NUMBER: 18-029-12

Rattle and/or Clatter Sound on Cold Start-up

2011 - 2012 MK Compass/Patriot

Fig. 1 Purge Solenoid Wire Harness

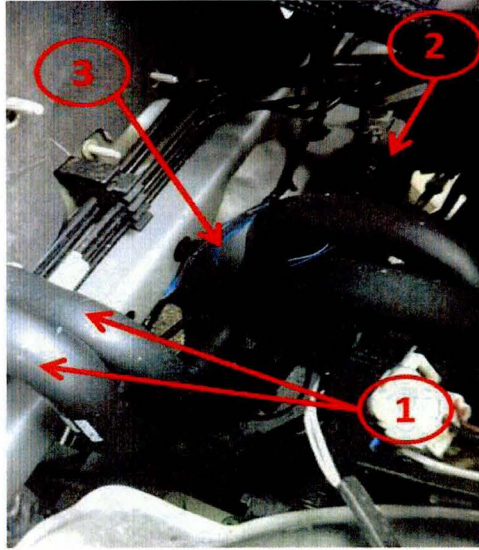
4. Without removing the pressure cap and with system not under pressure, turn draincock counterclockwise to open.
5. The coolant reserve bottle should empty first, then remove the pressure cap.
6. Allow cooling system to drain completely.
7. Remove both supply and return heater core hoses.
8. Install new heater core supply hose (p/n 05058822AB) and heater core return hose (p/n 05058823AB).
9. Install the right wheel inner splash shield.
10. Remove the engine cover.
11. To ensure that the purge solenoid wiring harness ([Fig. 1](#)) does not come in contact with the heater hoses, the wire harness will require a slight modification.

Fig. 2 Purge Solenoid Wire Harness Routing

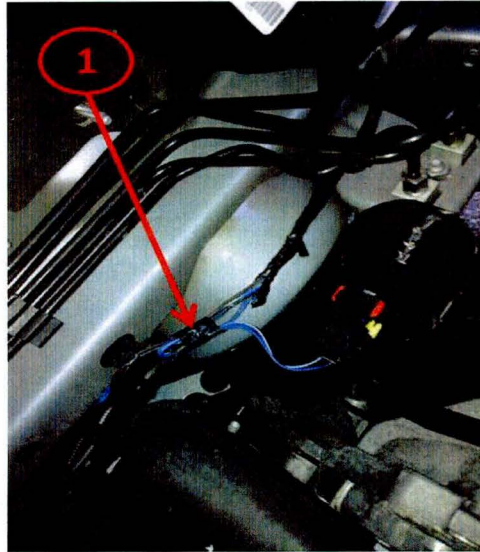
12. Loosely pull the purge solenoid wire harness straight and create a bend in the harness approximately 10mm (0.40 in. or 3/8 - 7/16 in.) away from the harness retaining clip edge. This bend will also create a natural bend after the current spot tape on the harness. Then, apply 3 - 4 wraps of electrical tape securing the bend to the harness as shown in (Fig. 2).
